Z-41
(2011)

PETITION NO: Z-41
HEARING DATE (PC): 11-01-2011

PROPOSED USE: Residential Condominiums

ZONING COMMENTS:

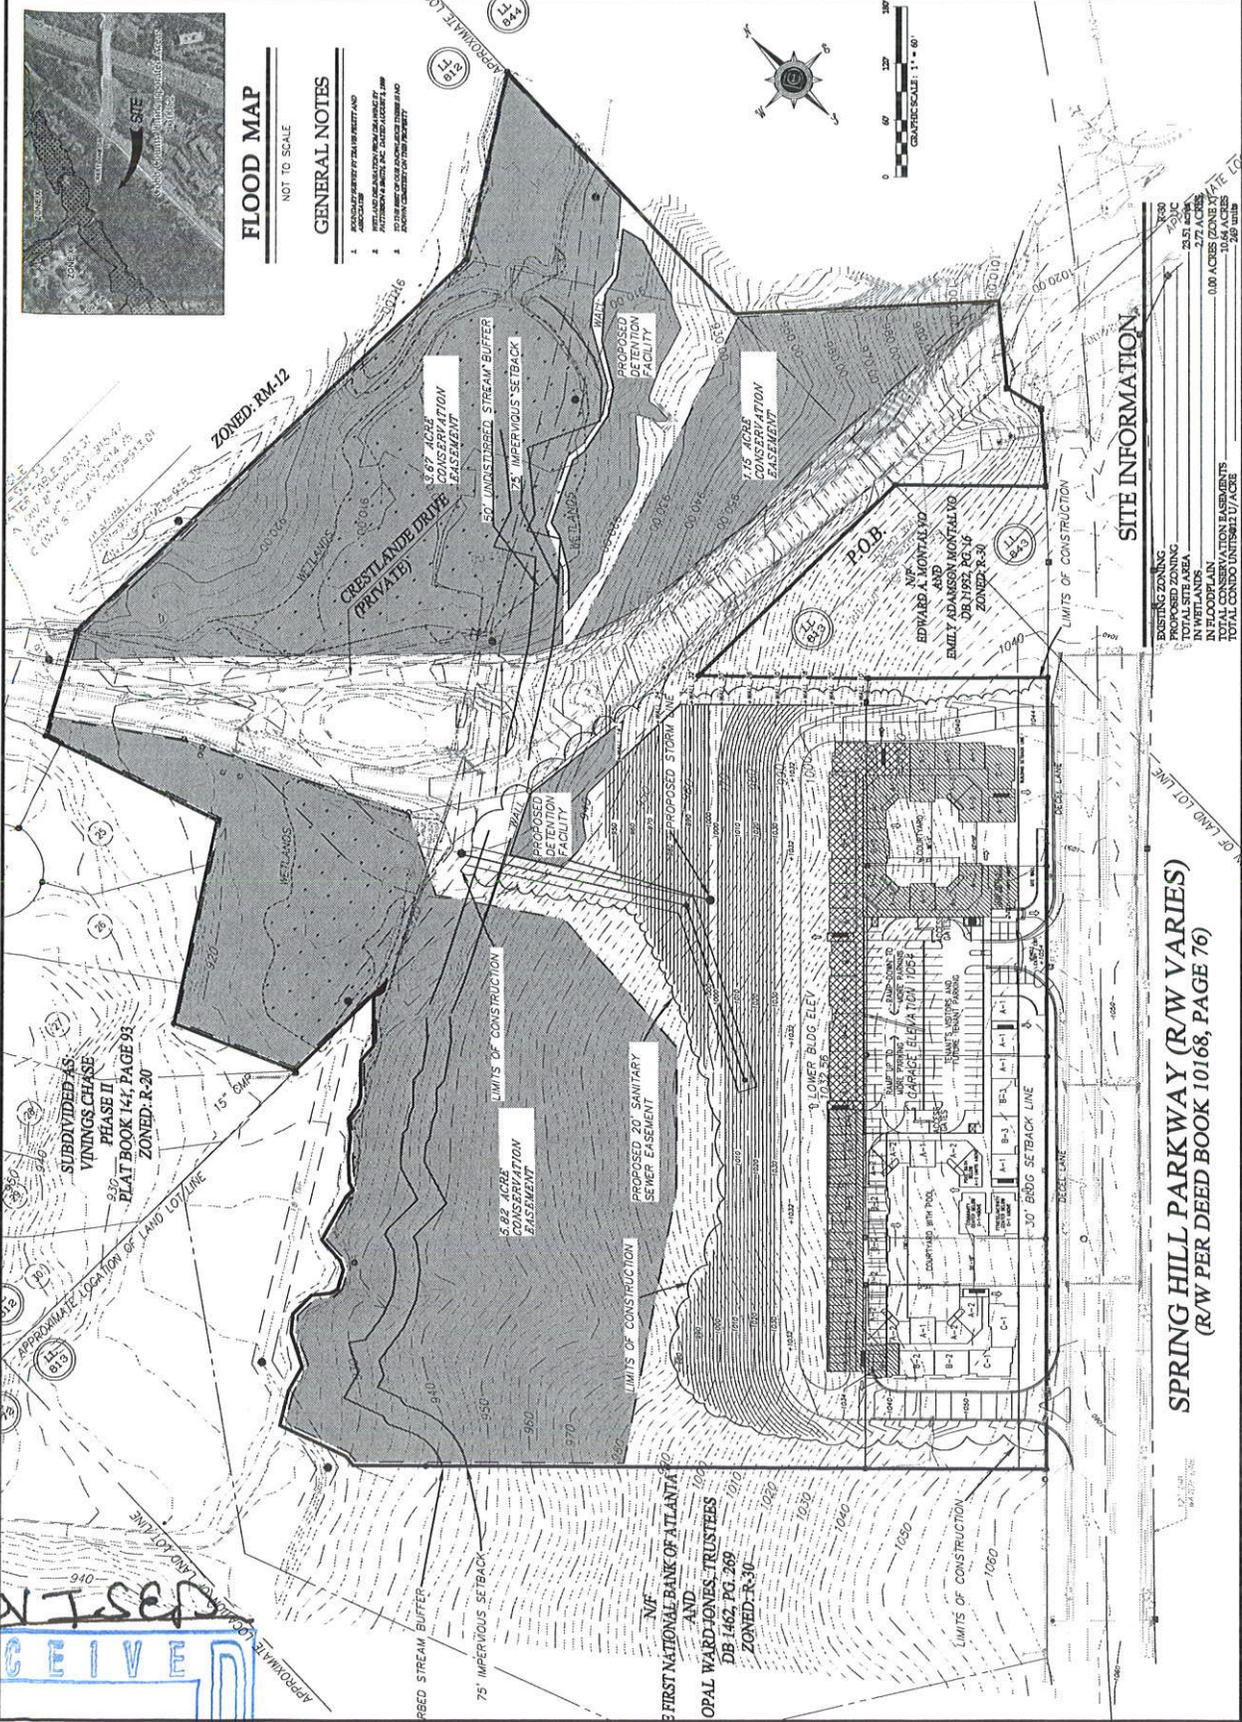
- FEMA Designated 100 year Floodplain Flood.
- Flood Damage Prevention Ordinance DESIGNATED FLOOD HAZARD.
- Project subject to the Cobb County Flood Damage Prevention Ordinance Requirements.
- Dam Breach zone from (upstream) (onsite) lake – need to keep residential buildings out of hazard.

Location: identified on plan

- Provide comprehensive hydrology/stormwater controls to include development of out parcels.
- Submit all proposed site improvements to Plan Review.
- Any **spring activity** uncovered must be addressed by a qualified geotechnical engineer (PE).
- Structural fill must be placed under the direction of a qualified registered Georgia geotechnical engineer (PE).
- Existing facility.
- Project must comply with the Water Quality requirements of the CWA-NPDES-NPS Permit and County Water Quality Ordinance.
- Water Quality/Quantity contributions of the existing lake/pond on site must be continued as baseline conditions into proposed project.
- Calculate and provide % impervious of project site.
- Revisit design; reduce pavement area to reduce runoff and pollution.

- No Stormwater controls shown _____
- Copy of survey is not current – Additional comments may be forthcoming when current site conditions are exposed.
- No site improvements showing on exhibit.

1. A significant portion of this site is encumbered by floodplain, wetlands and steep slopes. The proposed development will be located on slopes of 25 to 35% and fill heights of 10 to 40 feet. Due to the proximity of the stream, elevated erosion and sediment control measures will be required. At a minimum, a mulch berm should be placed along the lower clearing limit boundary to protect the stream buffer and proposed conservation easement area. The limits of disturbance could be significantly reduced with the use of retaining walls.
2. The proposed detention ponds must be located outside the 100-year floodplain and wetlands.

Recommend one full access driveway, one right-in/ right-out driveway and removing the northeastern full access driveway.

Recommend installing a deceleration lane for the full access driveway.

Recommend sidewalk along frontage.
